**REGULAR MEETING OF THE COMBINED PLAN COMMISSION/ZONING BOARD OF APPEALS**  
**Gregory J. Bielawski Municipal Center, Carol Stream, DuPage County, Illinois**

July 14, 2008

**# 07052:                    DAVID SCHONBACK -    Northeast Corner of St. Charles Road and Morton Road**  
***Zoning upon annexation to I- Industrial District***  
***Final Plat of Subdivision***  
***Variation – Rear Yard Setback***  
***CONTINUED FROM 6-23-08 MEETING***  
***Variation – Parking Lot Greenspace***

**# 08109: PRINCE INDUSTRIES – 745 N. Gary Avenue  
Special Use – Outdoor Activities and Operations  
Gary Avenue Corridor Review  
CONTINUED FROM 06-09-08 MEETING**

Views of Existing Landscape Screening in Front of the Building

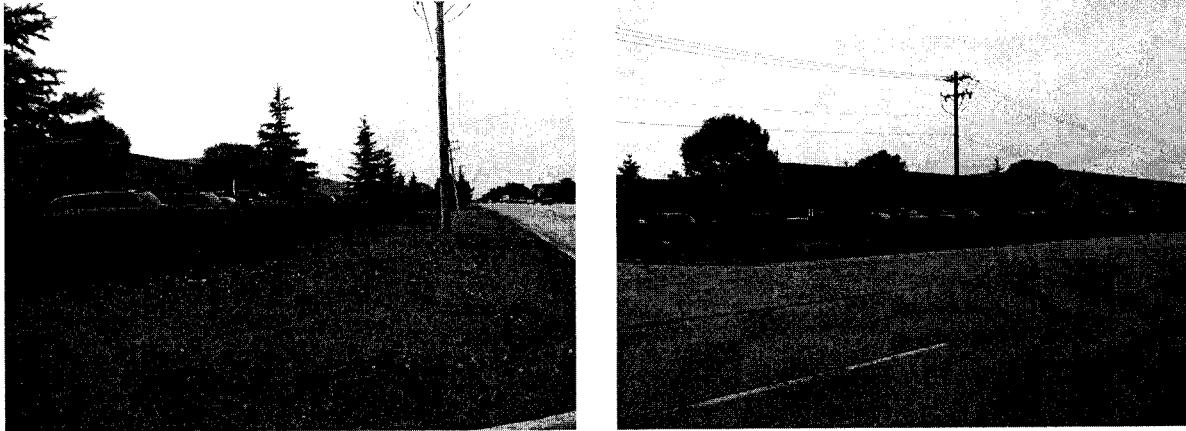
Section 16-5-6(E)(4)(g) of the GAC regulations states that any addition to or reconstruction of parking spaces shall conform with the GAC standards regarding parking and landscaping. The proposed Site Plan (Exhibit A) shows a total of 16 new parking spaces to be constructed within the GAC, 11 in front of the building and five at the rear of the site. All of the new spaces meet the GAC requirements with respect to number, size and setbacks. However, no landscaping is proposed for the 16 spaces. The GAC Regulations state that in the event of unusual circumstances, the property owner may request that the Plan Commission adjust the

applicability of the regulations to existing development. Staff notes that the existing parking lot was constructed in conformance with the zoning standards that existed at the time. We also note that the 16 new spaces within the Corridor are located in two separate areas, and that application of the parking lot landscaping requirements to either area would be inconsistent with the vast majority of the overall parking lot. In addition, as noted in the photos below, the existing lot in front of the building is well screened from Gary Avenue. For these reasons, staff is comfortable recommending that the GAC parking lot landscaping requirements should not apply to the 20 new spaces within the Corridor.
